Subject: Comments on Diridon Station Area Plan and EIR (Regarding bike infrastructure)

RE: Draft Program Environmental Impact Report for the Diridon Station Area Plan and Updated Draft Preferred Diridon Station Area Plan
(File No. PP09-163)

California High-Speed Rail Authority Comments to the City of San José
**Draft Program Environmental Impact Report for the Diridon Station Area Plan and
Updated Draft Preferred Diridon Station Area Plan**
(File No. PP09-163)

Re: Diridon Station Area Plan Draft Environmental Impact Report – File No. PP09-163

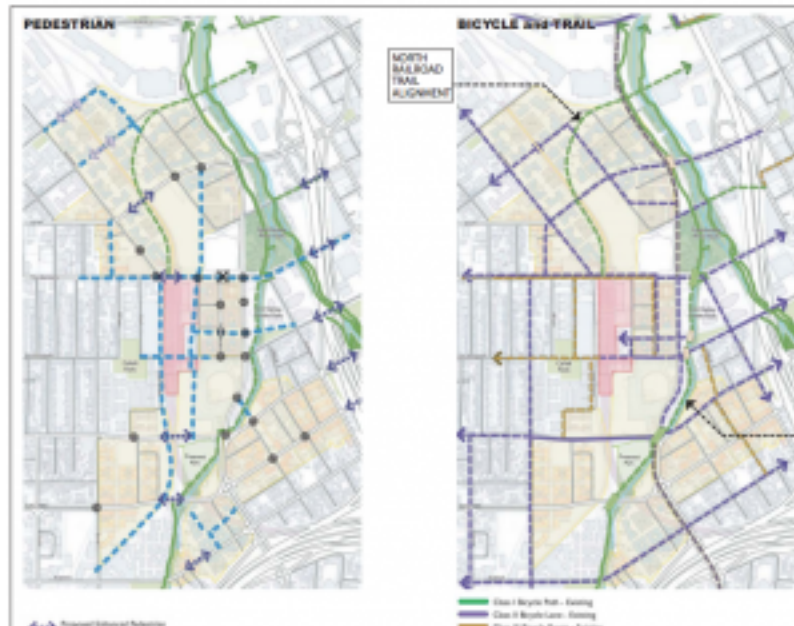
Friends of Caltrain and other transit, active transportation, and land use groups reviewing and supporting the plan are concerned that the biggest risks to the plan are in the implementation phases. The plan has an extremely ambitious goal of reducing solo car commuting to 40% by 2040. This is even more aggressive than San Francisco's 50% goal for the city, and more aggressive than Mountain View's 45% goal for North Bayshore where Google is headquartered.
